Battery Starter Lug Failure CXU, GU

FSB 371-045, Battery Cable Lug, Failure

(May 2013)

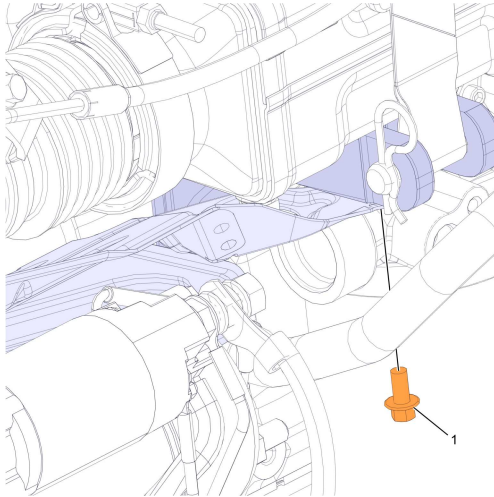
Certain vehicles built from January 1, 2010 to May 28, 2013 with a MP7 engine may experience cracking or breaking of the 90 degree positive battery cable lug at the starter solenoid stud. In some cases, the lug is bent during assembly, and along with engine vibration may cause the terminal to weaken and fail over time.

To support the cable and eliminate this failure, follow the procedure below:

W2080360

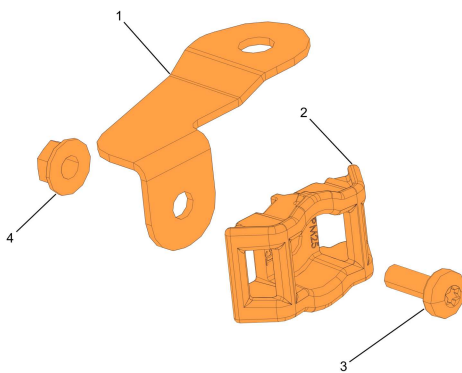
- 1 Secure the vehicle for service by parking it on a flat level surface, applying the parking brake, chocking the rear wheel, and placing the transmission in neutral.
- 2 Disconnect all cables from the negative (ground) battery terminals to prevent personal injury from electrical shock and prevent damage to electrical components.
- 3 Remove the fastener from the heat shield bracket.

W2080361

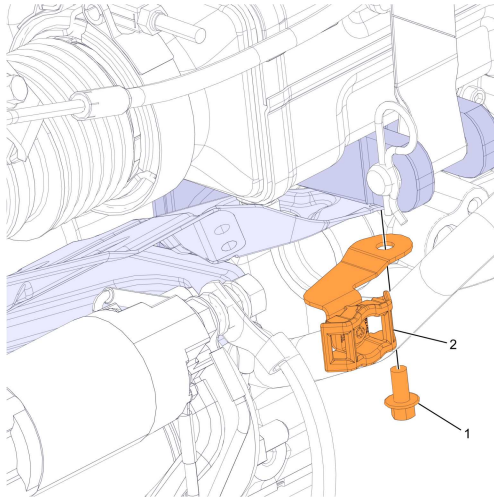
- 4 Preassemble the bracket and the saddle.

W2080362

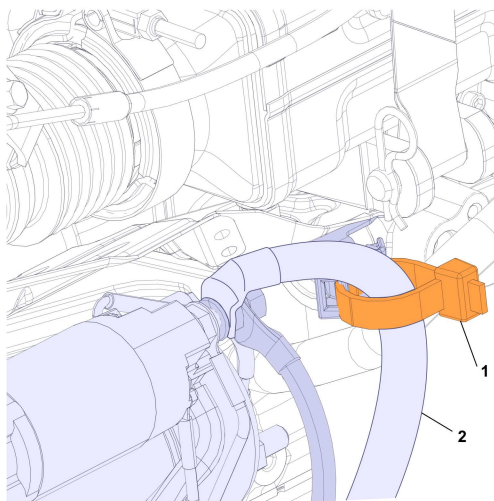
- 5 Install the bracket onto the vehicle and secure.
